ASSESSMENT REPORT

Jacfin Ropes Creek Project Section 75W Modification – Transgrid Land Exclusion MP 10_0127 MOD 1 and MP 10_0128 MOD 1

Figure 6: Modified Project Stage 1

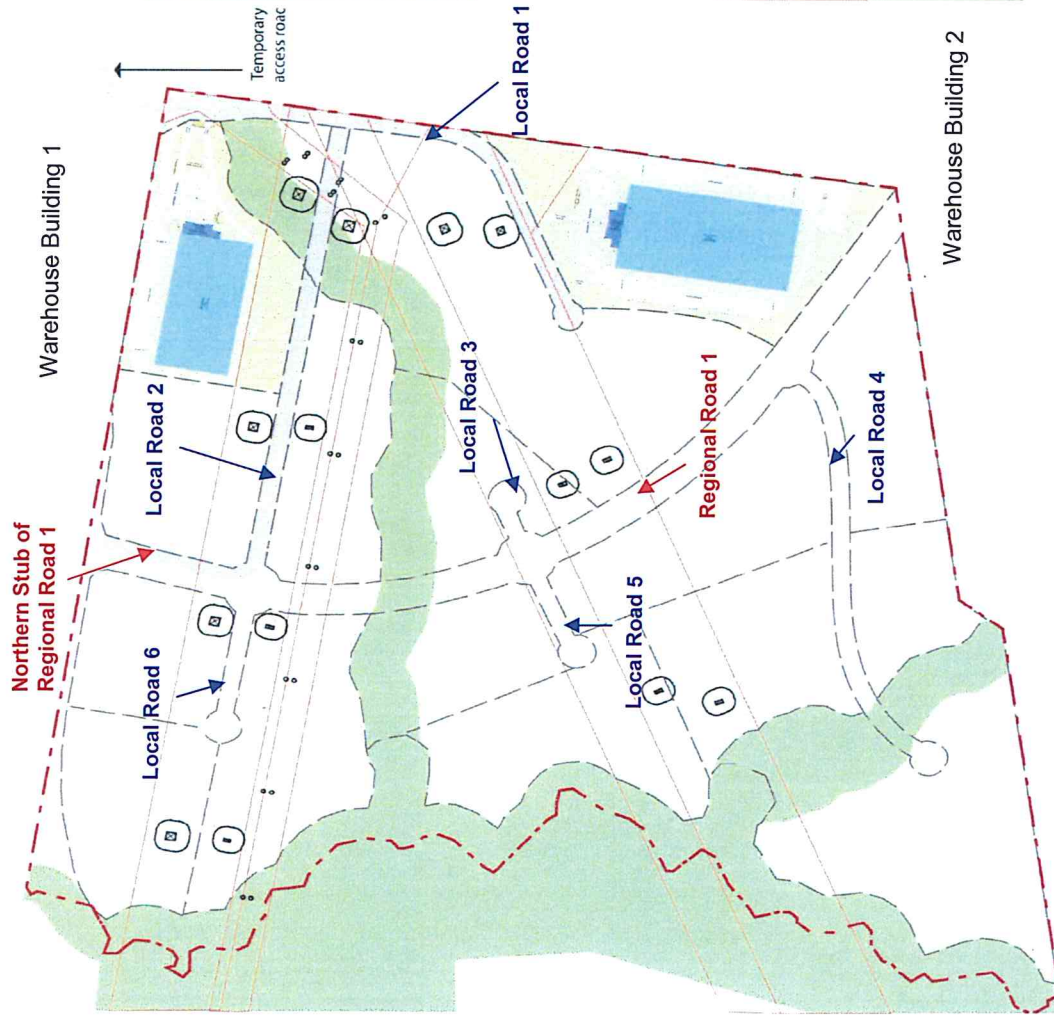
- the E2 zone on the site to be restored, managed and maintained in accordance with a formal management plan;
- the indicative building footprints on the irregular shaped parcel of land that would be created by the Transgrid acquisition (see Figure 4) to be removed from the concept plan because it could be misleading in terms of its actual developable viability;

| Issue | Assessment | Recommendation |
|---------------------|---|--|
| Design and Land Use | <ul style="list-style-type: none"> Council raised some concerns about the actual developable viability of some irregular shaped land created by the Transgrid acquisition (see Figure 4) and considered the Site Development Guidelines (SDGs) for the concept area need to be approved as part of the modified concept plan to guide future stages of the development (see detail in Section 4 of this report). In the RTS, Jacfin noted that the building footprints on the approved concept plan are indicative only and that Stage 4 would be subject to | <p>Modified Environmental Assessment Requirements are recommended in the concept approval which require all future DAs in the concept area to ensure buildings are designed (e.g. height, bulk, scale and parking) in</p> |
